JAMES A. FITZPATRICK NUCLEAR POWER PLANT

AMENDMENT TO FACILITY OPERATING LICENSE

Amendment No. 57
License No. DPR-59

SAFETY EVALUATION BY THE OFFICE OF NUCLEAR REACTOR REGULATION
SUPPORTING AMENDMENT NO. 57 TO FACILITY OPERATING LICENSE NO. DPR-59
POWER AUTHORITY OF THE STATE OF NEW YORK
JAMES A. FITZPATRICK NUCLEAR POWER PLANT
DOCKET NO. 50-333

FIGURE 6.2-1

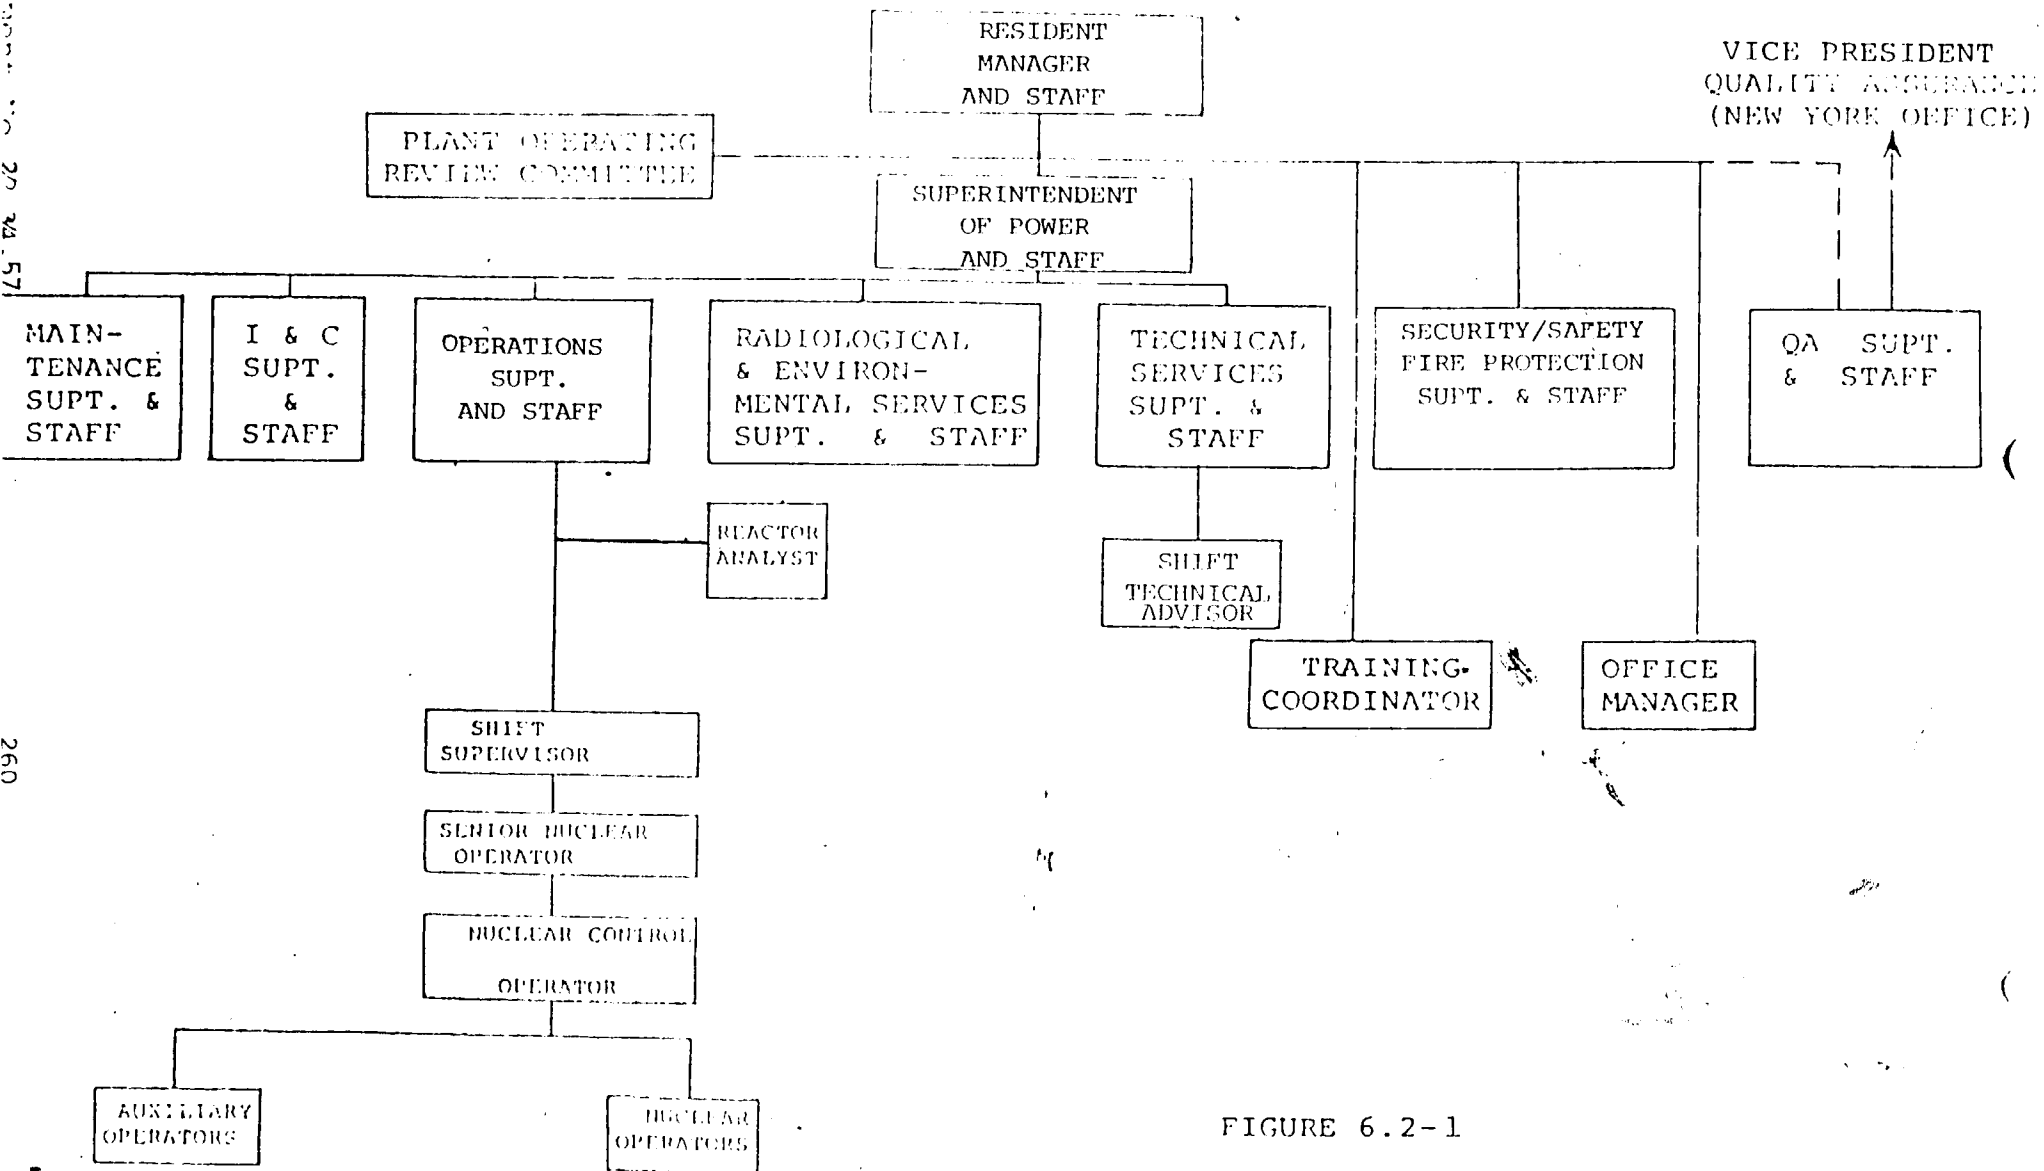
Our request indicated that the TSs related to minimum shift manning should be revised to reflect the augmentation of an STA. The STA function includes both accident and operating experience assessment. The licensee response proposed TS changes which provide for the Shift Technical Advisor. We have reviewed these changes and conclude that the licensee has satisfied this requirement.
